**Re: DIRECT TESTIMONY OF EDWARD BURGESS ON BEHALF OF ATTORNEY
GENERAL'S OFFICE
Docket No. E-100, Sub 190**

DOCKET NO. E-100, SUB 190

In the Matter of:)	
)	
Duke Energy Progress, LLC,)	DIRECT TESTIMONY OF
and Duke Energy Carolinas,)	EDWARD BURGESS
LLC, 2023 Biennial)	ON BEHALF OF
Integrated Resource Plans)	ATTORNEY GENERAL'S
and Carbon Plan)	OFFICE

**Table AGO DR4-29 - Coal Unit Retirements and GRRs (effective by January 1
 of year shown) - Reference Table F-7 in CPIRP**

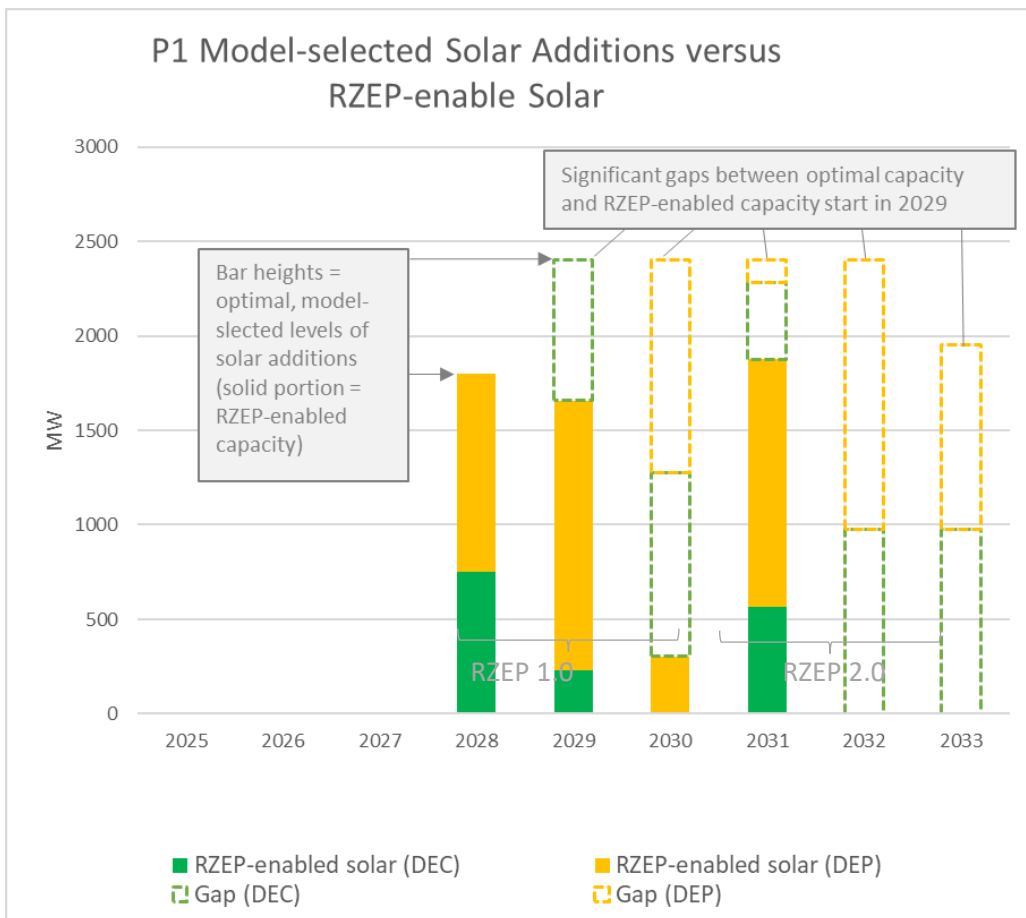
1 A. I don't believe so. If that were the case, the process required to timely place into
 2 service that alternative also has not been pursued. As the table below shows,
 3 the Generator Replacement Request (GRR) submittal would have needed to
 4 occur in 2023 for Mayo to align with a 2029 retirement date. Notably, GRR
 5 submittals for Belews Creek 1 and 2 have also not yet occurred and would need
 6 to occur this year (2024) to align with a 2030 Interim Target. In summary, it
 7 doesn't appear that Duke's recent actions related to coal retirements are
 8 consistent with its own analysis on what is necessary to achieve the 2030
 9 Interim Target.

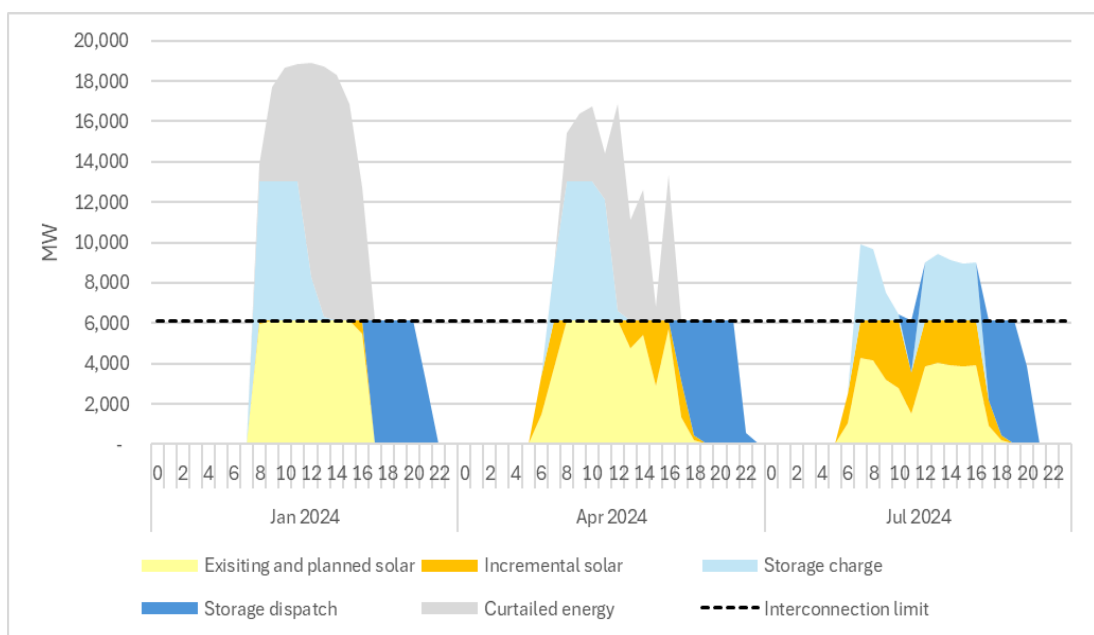
12
13 There are two potential ways this might be accomplished. Both approaches
14 would go beyond what Duke's modeling assumes and would increase the
15 overall MWh output of solar resources, even under the strict annual MW limits
16 Duke uses. First, the amount of MWh delivered per MW of resources could be
17 significantly enhanced by using an "oversized hybrid" configuration that
18 significantly increases the MW-dc capacity of the solar panels behind the point
19 of interconnection and uses storage to capture a significant amount of the
20 energy that would otherwise be curtailed. Duke's standard assumption for solar
21 plus storage resource output is a 27% capacity factor (per MW-ac), I have
22 conducted analysis on a hypothetical NC-specific solar resource and found that
23 an "oversized hybrid" configuration could increase this value to 35%. Targeting

1 this type of resource in Duke’s procurement activities could theoretically
 2 increase the portfolio total of solar energy delivered (in MWh) in 2032 by 30%,
 3 without changing the annual limits on MW-ac solar additions that Duke has
 4 assumed. An illustration is provided below:
